Bio Plas, Inc.

Cat# 3250 - 5 ML MACRO TIPS

Product Change Notice!

SUMMARY OF CHANGE

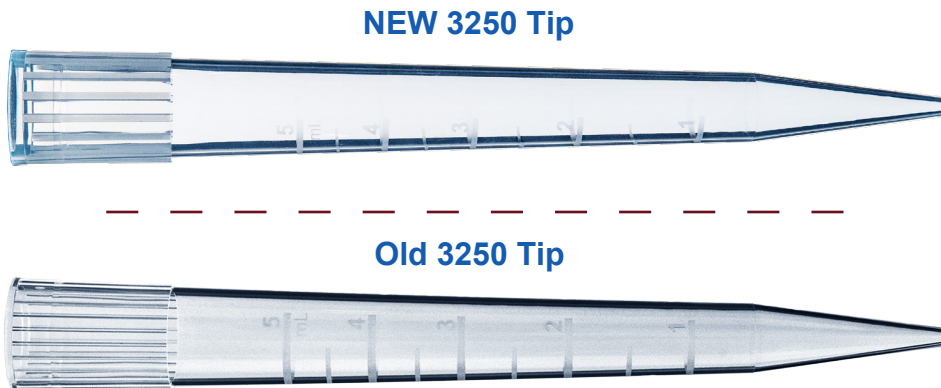
- We have incorporated a new mold for these tips to improve our efficiencies and increase our production capacity. There is a slight change in the number of ribs on the top exterior crown of the tip which has no effect on its fit, form or function.

- The new mold incorporates a hot-runner system that facilitates faster cycle times and reduces plastic waste by 25%, compared to the cold-runner system.

- Your customers may notice the change in the appearance of the 3250 tips. Again, only the ribbing is changed; the tips are unchanged in fit, form and function.
